New OMB Multivalve

Main differences and improvements

In and out connections

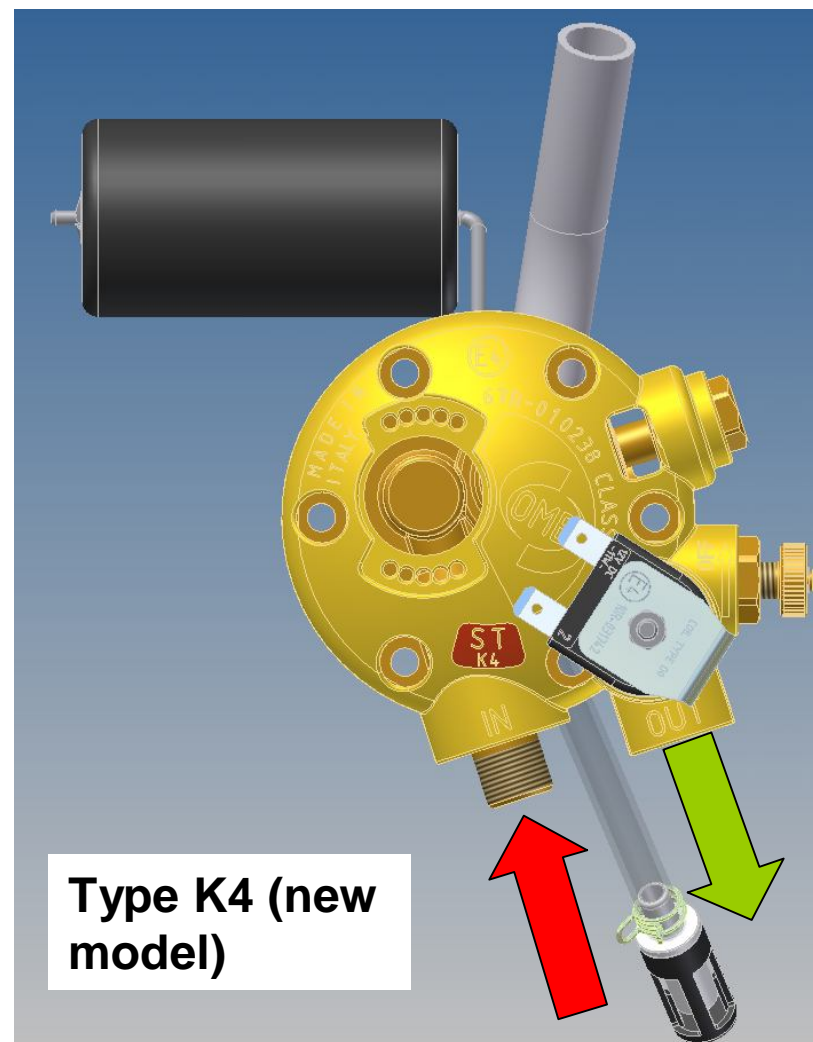
Input ←

Output →

Type B1
(Old model)

Type K4 (new
model)

Tank connection

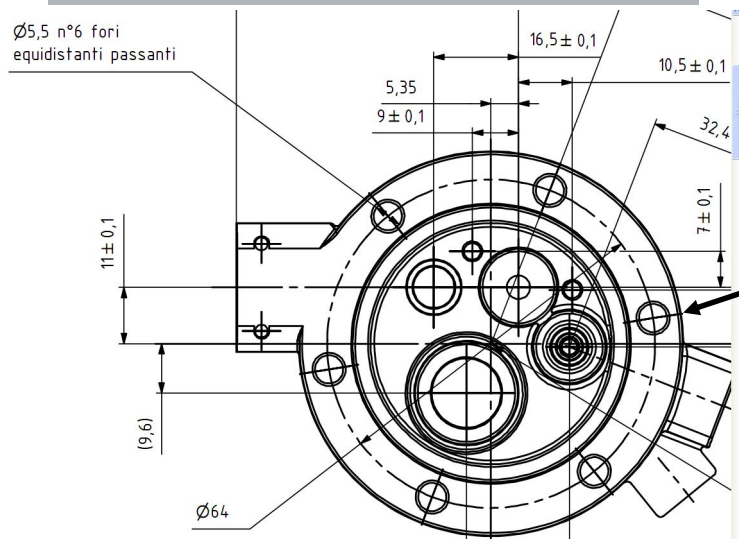
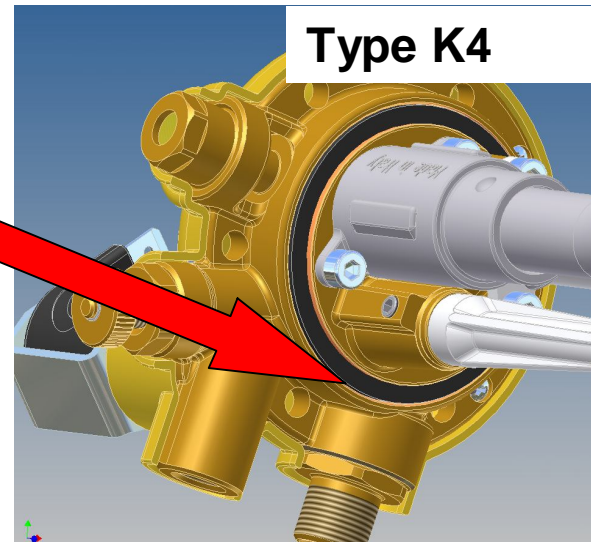
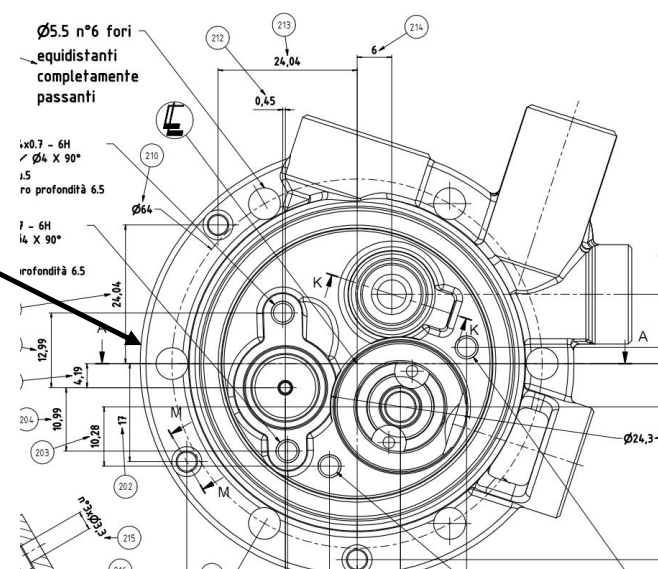
Same gasket

Same 6 hole
to connection
with tank

80% stop device and non-return valve

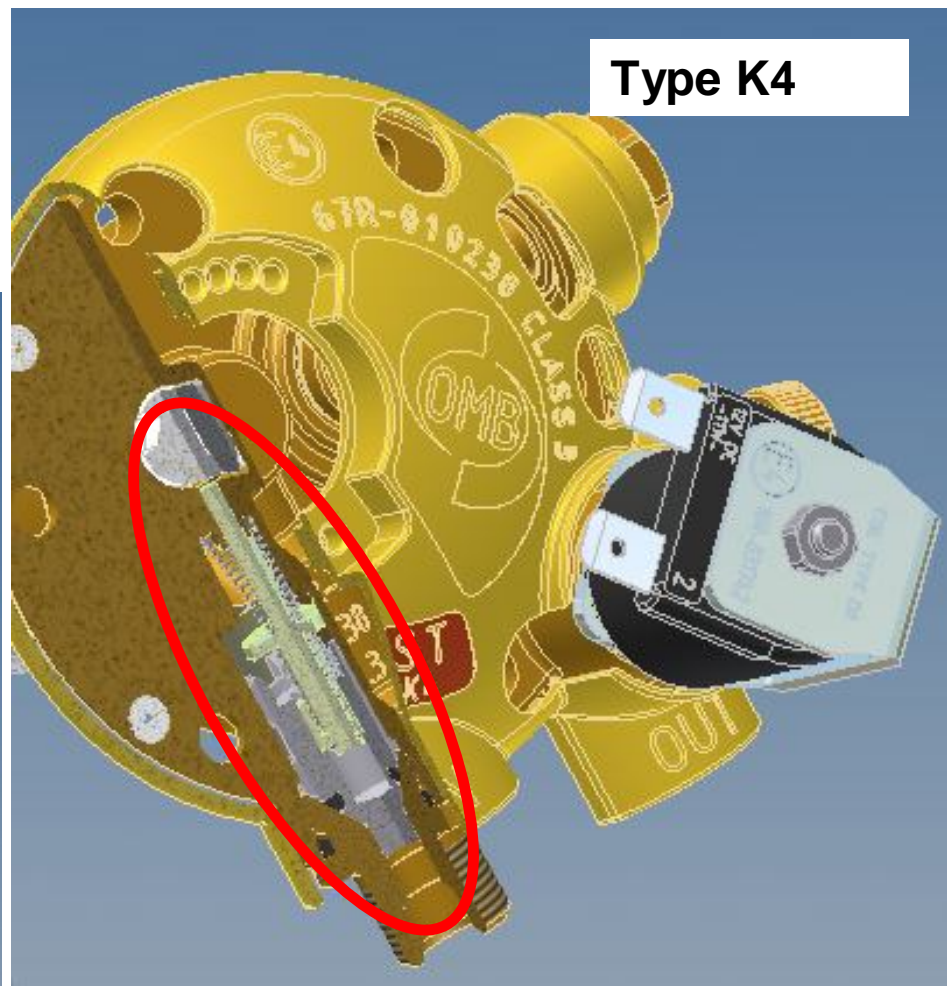
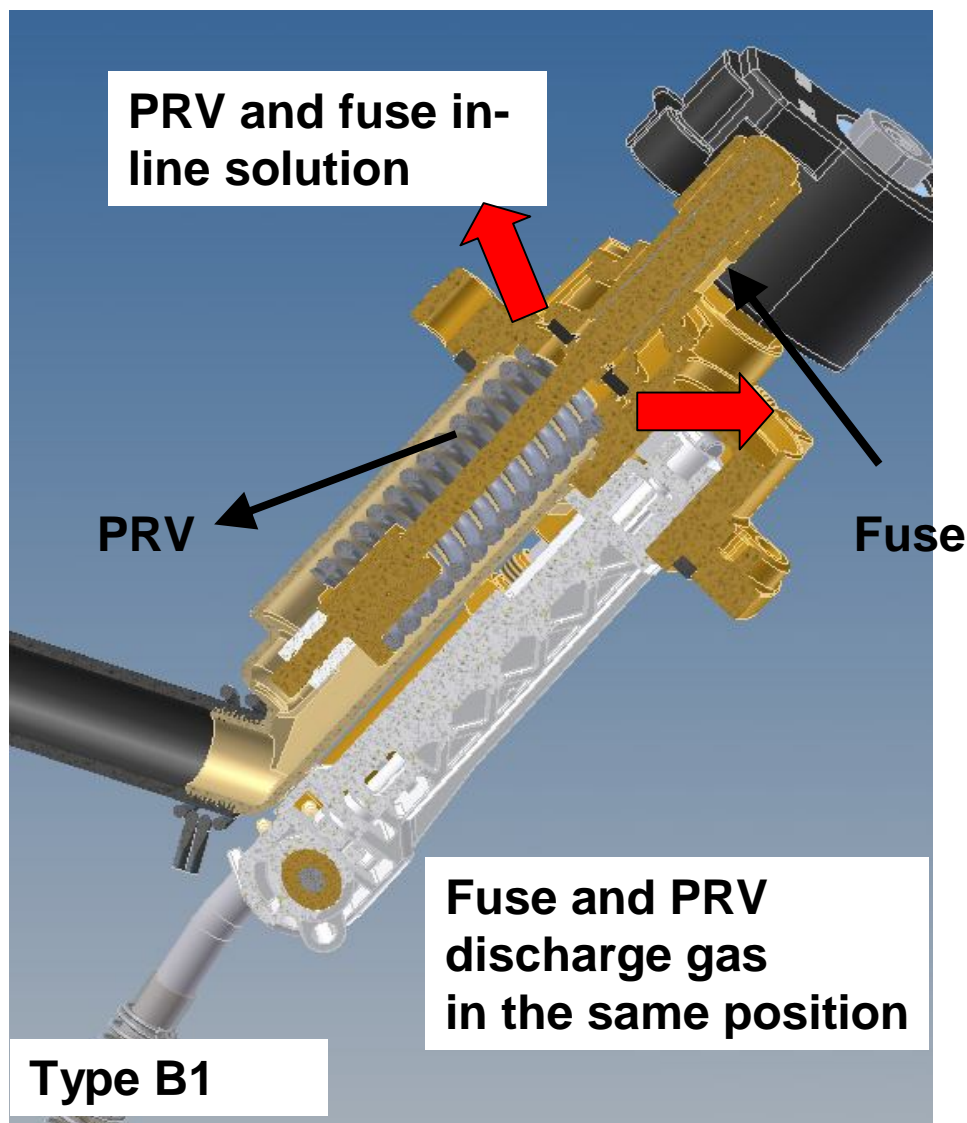
Type B1

Type K4

Pressure relief valve (PRV) and fuse differences

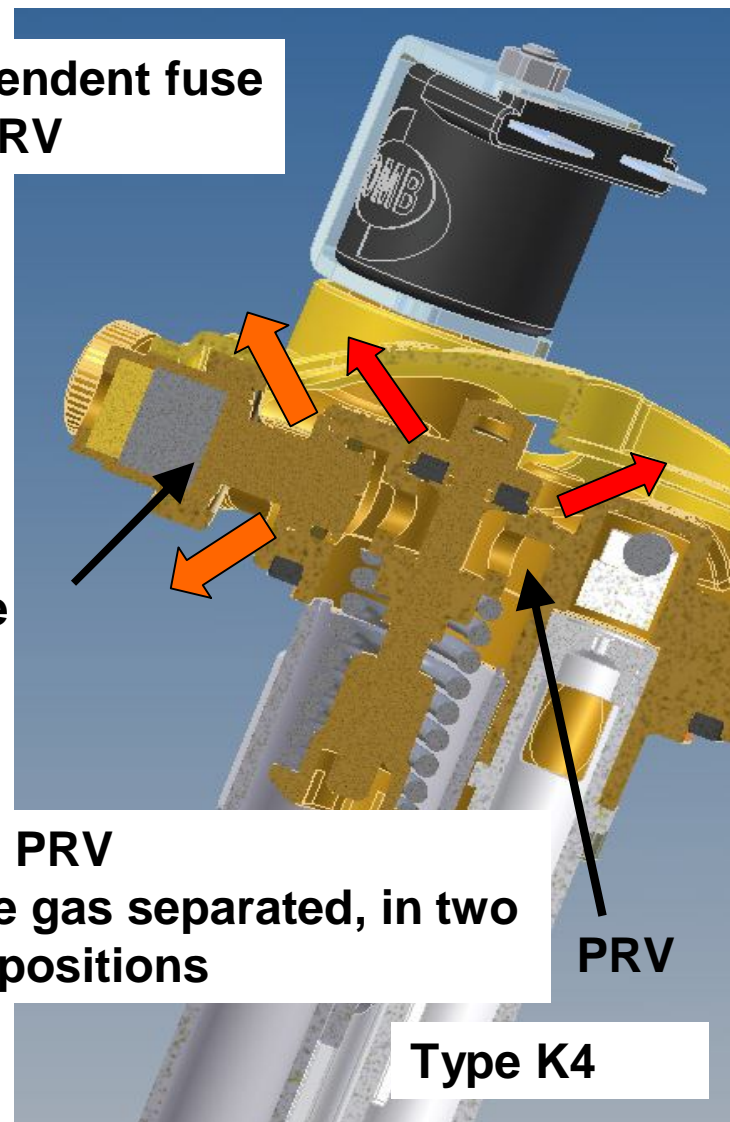
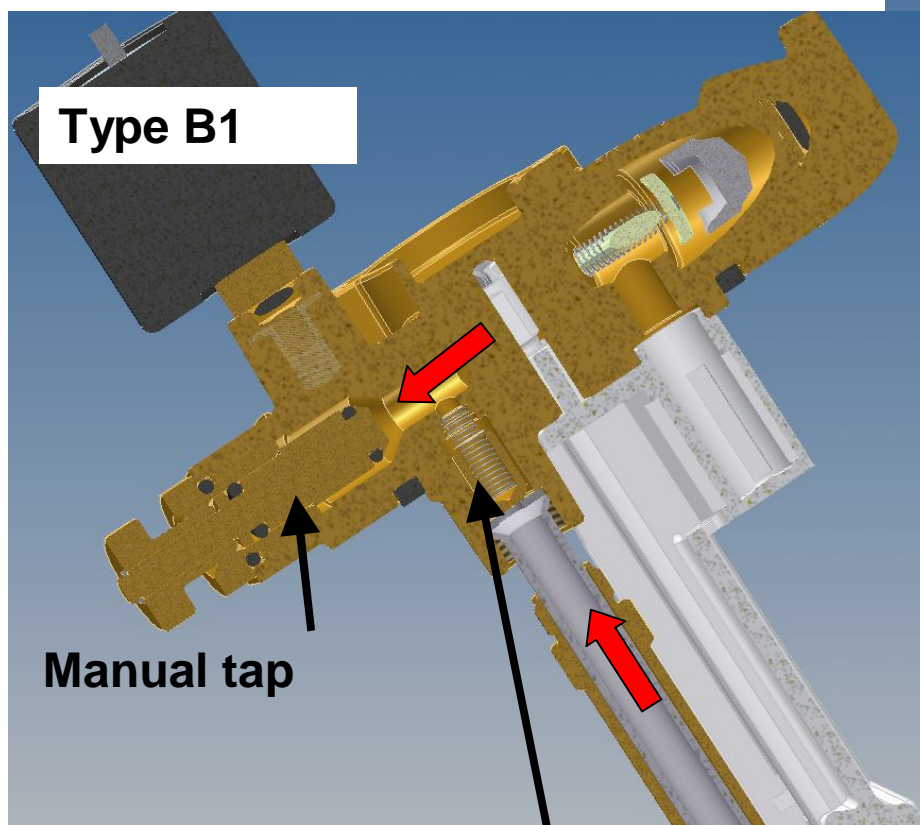
Independent fuse and PRV

Fuse and PRV discharge gas separated, in two different positions

Output line : excess flow valve and manual tap

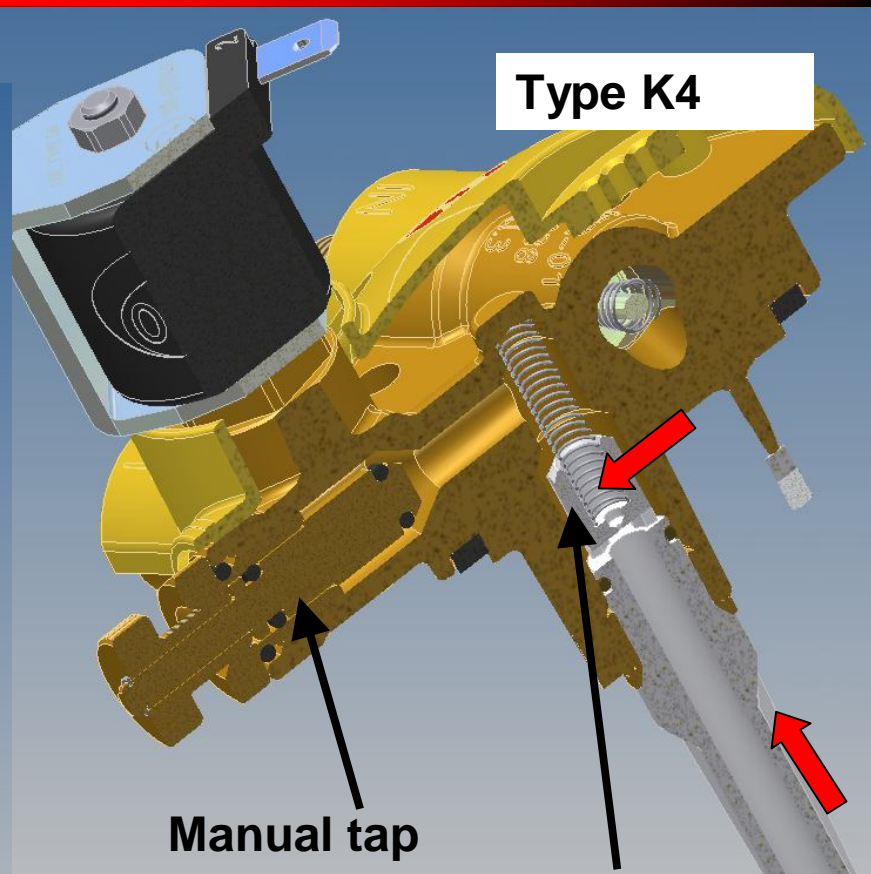
**Excess flow
valve**

**Excess flow
valve**
